**H.263
Implementors'
Guide**

**Implementors Guide for H.263: “Video coding
for low bit rate communication”**

5 Technical and Editorial Corrections to H.263

5.1 Division operation in Figures Q.8/H.263 and Q.9/H.263

Figure Q.8/H.263 – Creation of reconstructed prediction error for pixels inside block

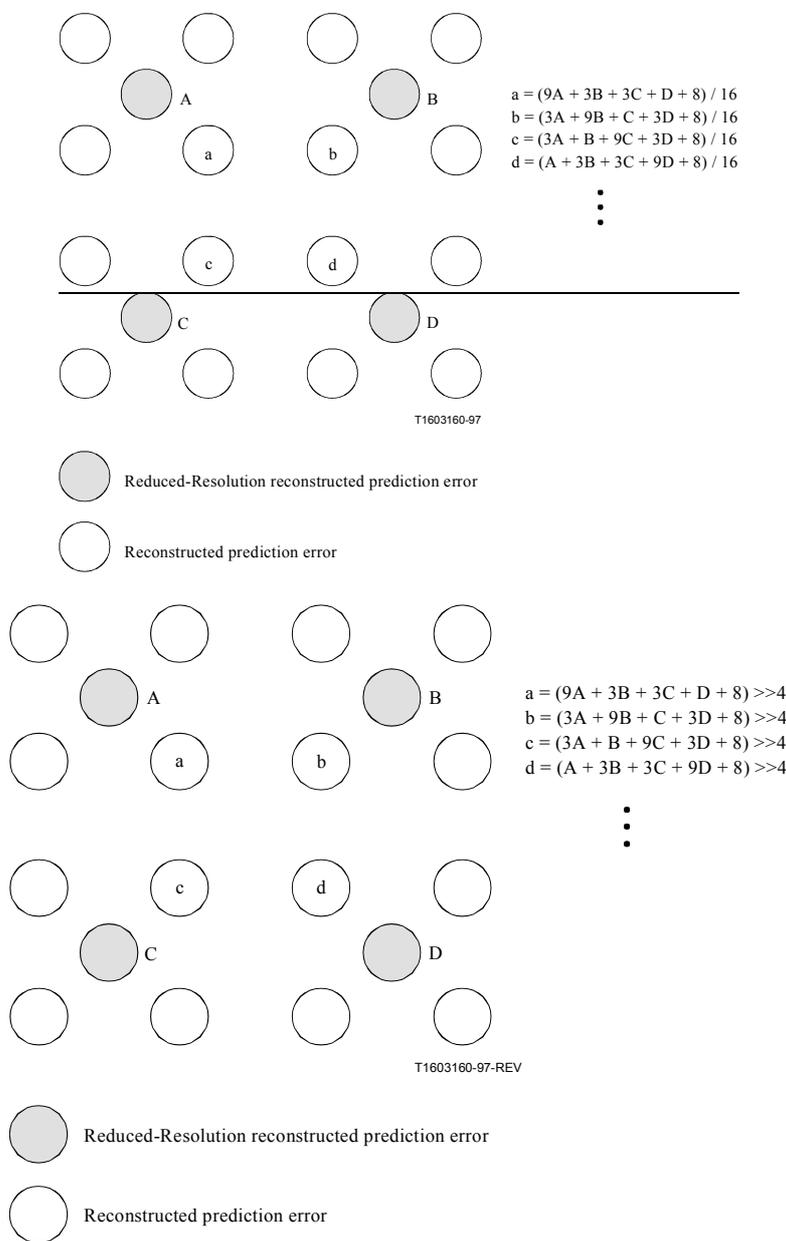
Description:	<p>The currently-specified rounding in subclause Q.6.1 Figure Q.8/H.263 and subclause Q.6.2 Figure Q.9/H.263 specifies a division by a denominator value D of the form $D = 2^K$ where K is a positive integer constant. In Figure Q.8/H.263, the value of D is equal to 16 (and thus K is equal to 4 in this case). In Figure Q.9/H.263, the value of D is equal to 4 (and thus K is equal to 2 in this case).</p> <p>The equations found in these figures in the Recommendation specify to perform a rounding division of some numerator N by this denominator using equations of the form as follows:</p> $\text{Result} = (N+D/2) / D$ <p>where the "/" symbol denotes division with truncation of fractional remainders toward zero.</p> <p>These equations appear to produce undesirable results when the numerator N is less than zero, which is possible in these equations of the Recommendation.</p> <p>For example, the current rounding specification would cause a problem if N is equal to $-1.25 * D$. In such a case, the computed result of the rounded division would be 0 instead of the likely intended value of -1.</p> <p>The tentative corrected interpretation suggested for implementers is to change these equations to the form as follows:</p> $\text{Result} = (N+D/2) \gg K$ <p>where the ">>" symbol denotes an arithmetic right-shift operation that removes the least-significant K bits in a two's complement representation of (N+D/2). For example, using this interpretation, the result will be equal to -1 if N is equal to $-1.25 * D$, will be equal to -1 if N is equal to $-1.5 * D$, will be equal to +1 if N is equal to $1.25 * D$, and will be equal to +2 if N is equal to $+1.5 * D$.</p>

The creation of reconstructed prediction error for pixels inside block is described in Figure Q.8. "/" indicates division by truncation.
